POLICY ISSUE NEGATIVE CONSENT

SECY-03-0079

SUBJECT: NRC REVIEW OF IDAHO NATIONAL ENGINEERING AND ENVIRONMENTAL LABORATORY DRAFT INCIDENTAL WASTE (WASTE-INCIDENTAL-TO-REPROCESSING) DETERMINATION FOR TANK FARM FACILITY CLOSURE

U. S. NUCLEAR REGULATORY COMMISSION
REVIEW OF IDAHO NUCLEAR TECHNOLOGY AND ENGINEERING CENTER
DRAFT WASTE-INCIDENTAL-TO-REPROCESSING DETERMINATION FOR
TANK FARM FACILITY RESIDUALS

Figure 4. Illustration of the two-dimensional modeling slice used in PORFLOW

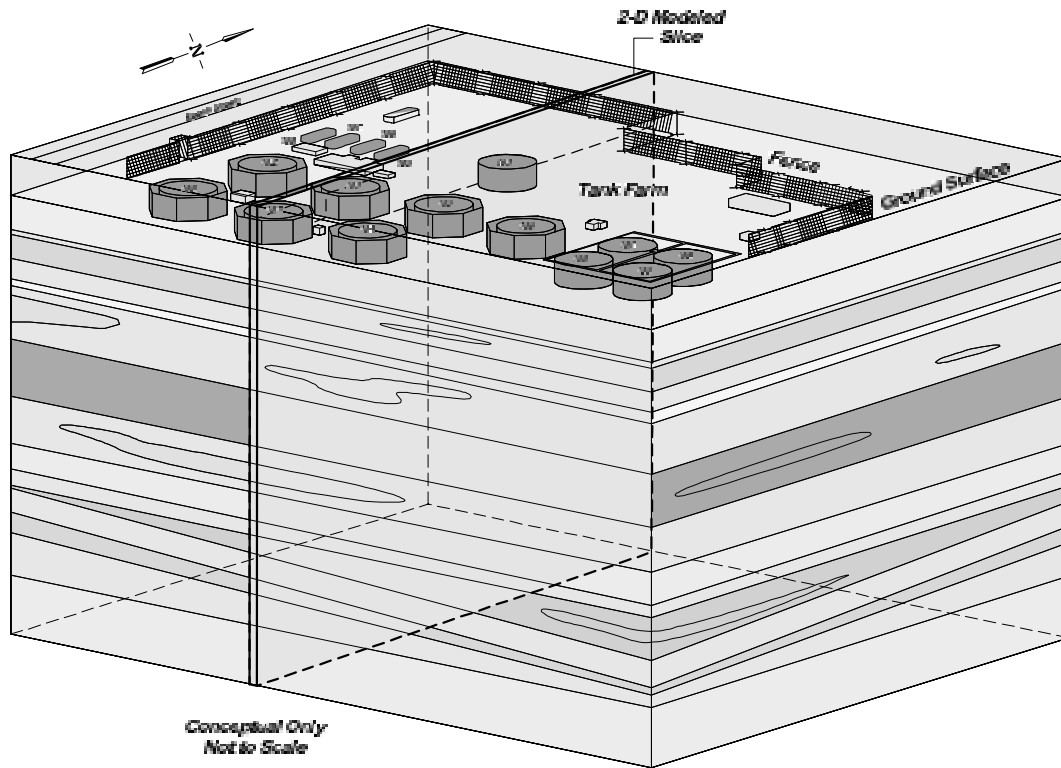
A two-dimensional unsaturated/saturated model (PORFLOW) was used to simulate water and contaminant transport in the subsurface at the INTEC TFF [28]. Figure 4 is an illustration of the model. The two-dimensional model allowed a detailed approximation of the geology underlying the facility. With 103 vertical layers, DOE-ID modeled the complex geology underlying the TFF from the Big Lost River in the north, through the center of two tank vaults, and southward for a total distance of 2500 m (8200 ft) in the downgradient direction. The top boundary was located at the ground surface, the bottom at 200 m (700 ft) below ground surface, and the water table elevation varied between 134 and 139 m (440 and 456 ft) below the ground surface within the model domain. A uniform net infiltration flux formed the top boundary condition for the model, with the exception of simulations that incorporated seepage from the Big Lost River, and a no flow boundary condition was present at the model base. A wide range in infiltration rates at the site [0.41 to 12.0 cm/yr (0.16 to 4.7 in./yr)] is reported in the literature, some of which were determined with site-specific studies [3]. In the revised PA submitted to the NRC, infiltration rate was considered to be an uncertain parameter and was included as part of the sensitivity/uncertainty analyses. The north and south unsaturated zone boundaries were no flow, whereas the north and south saturated zone boundaries were set to constant hydraulic head values, based on the regional potentiometric surface.

As a result of hydrologic uncertainty, DOE-ID made certain assumptions in an attempt to provide a reasonable model of present and future hydrologic conditions. Existing hydrologic and geologic data were used if possible. When there were conflicting sources of data, an attempt was made to confirm the data by consulting additional sources. If there was no information available, then a conservative approach was adopted that resulted in using parameters that resulted in the highest transport rates. For example, if the only available information for a particular geologic unit was a range in hydraulic conductivity values, then the upper portion of the range was used in the model.

The overall modeling approach appears to be a reasonable attempt to manage uncertain hydrologic and geologic information. It appears, in general, that DOE-ID appropriately assessed the TFF transport system through use of conservative assumptions. These conservative assumptions help to simplify the transport model as well as add confidence in the output. Conceptual model uncertainty can, in some cases, significantly impact the risk when transport is through a fractured, unsaturated hydrologic system. Confidence is gained with the DOE-ID approach as a result of the comparisons of the model predictions for tritium movement with the observations [36].
